TECHNICAL NOTE

Project Title: Hinckley NRF Interchange

Report Reference: 794-PLN-TRP-JNY10702-11

Further Review of DCO Transport Assessment

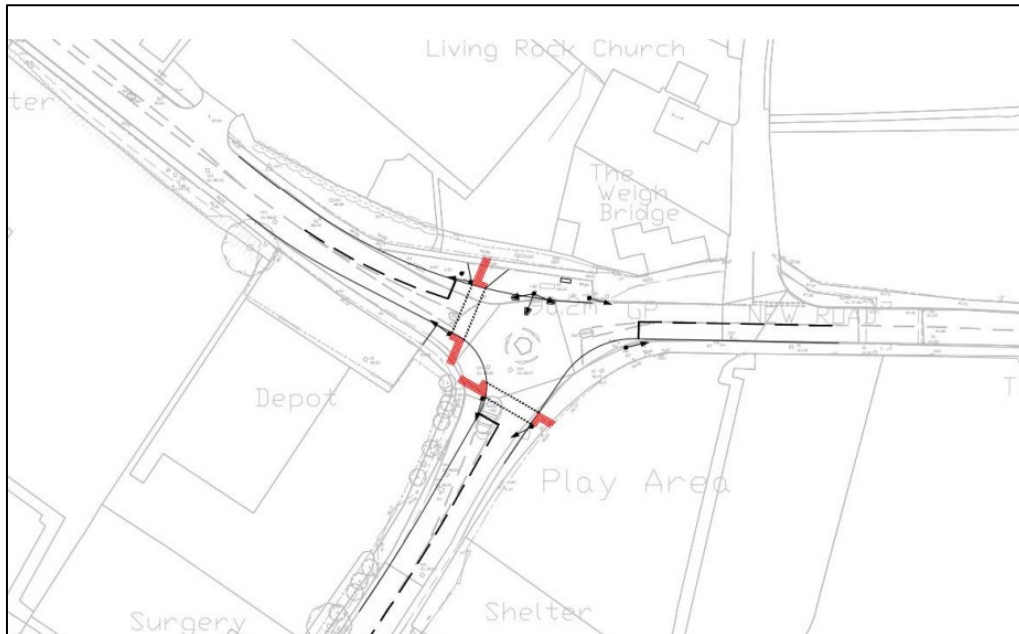
- 1.31 The recommendations of the audit team effectively require the relocation of two private accesses either side of the junction and a restriction to existing residential car parking. In the absence of these alterations the two crossing points either side of the junction on New Road cannot be provided.

- 1.32 The Designers Response to this is to remove the eastern crossing from the scheme and amend the junction to accommodate the existing crossing to the west of the scheme. This is shown in the extract below.

- 1.34 In conclusion on this issue, it is considered that the removal of a pedestrian crossing from the junction which was to enhance pedestrian safety is a detrimental effect. RPS remain of the view that the measures proposed at this junction together with the lack of measures at the New Road / Long Street junction do not address the impact of the development within Stoney Stanton, and that the residual overall cumulative impact on Stoney Stanton will be severe in the context of Paragraph 115 of the NPPF (December 2023).
